Subject: AP1000 Response to Request for Additional Information (SRP3)

RAI-SRP3.9.3-EMB2-05 R1

AP1000 TECHNICAL REPORT REVIEW

RAI Response Number: RAI-SRP3.9.3-EMB2-05
Revision: 1

Figure 1 Cut 2 Location (typical all nozzles)

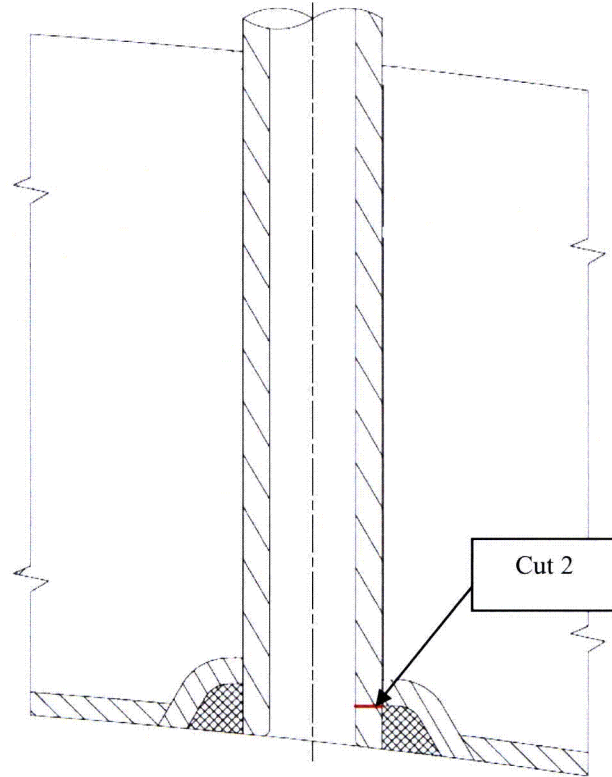
Reactor Vessel – The design reports for the RV head penetrations indicate that the primary plus bending stresses at the J-groove weld did not satisfy the Code allowables. The reports split the stress components at these locations and justified that since the vessel wall would provide constraints in the radial and circumferential directions, the axial stress component satisfied the Code. Code does not allow splitting stresses for the purpose of satisfying the Code. Provide additional information on how the Westinghouse methodology meets the Code for J-groove weld design.

Demonstrate with additional information or a detailed analysis how Westinghouse plans to meet the Code requirements for the J-groove weld designs associated with CRDM, UMI and vent pipe penetrations.

Westinghouse claimed that since the penetration tube is constrained in radial and circumferential directions, the vessel would not allow any ratcheting in these directions. Now since all requirements of NB-3228.5 are satisfied in the axial direction, no significant effect due to thermal ratcheting in the axial direction would occur. However, the staff's concern is that the design report for the RV head penetrations split the stress components at these locations to justify the satisfaction of the Code requirements. NB-3228 is based on stress intensities and does not allow splitting stresses for the purpose of satisfying the Code. Westinghouse did not demonstrate why a plastic analysis is not necessary. Westinghouse in its response to -05, Rev. 0 reiterated statements included in the audited design reports.

This conservative approach does not satisfy the limits of NB-3228.5(a) so the Code rules are used to perform a more realistic evaluation using membrane and bending stresses normal to the plane of reference. The only stress plane (cut or line) which exceeded the NB-3228.5(a) limit is the cut through the tube illustrated in Figure 1 (cut 2). Using this approach, NB-3228.5(a) is met with very large margin. This approach is within the Code rules specified in the Code definitions.

The equation is satisfied by addressing the purpose for the equation, which is to limit the potential excessive distortion due to incremental plasticity, sometimes referred to as stress ratcheting. The location where this is applied is at the stress cut shown in Figure 1, through the tube, just above the J-groove weld.

The issue is essentially identical for all penetrations so one penetration type, the CRDM, is used to illustrate the stresses which contribute to the total stress intensity used in this stress check. Table 1 summarizes the stress components for a typical case. The final line "Total - Th Bnd" reflects the stress to use for this limit. As this table illustrates the overstress is caused by the large hoop stress combined and to a lesser degree, the axial stress.

The ratchet mechanism cannot occur from hoop stress. The stresses in the radial and axial directions are well less than the limit (3Sm) and therefore the component meets the Code requirements.
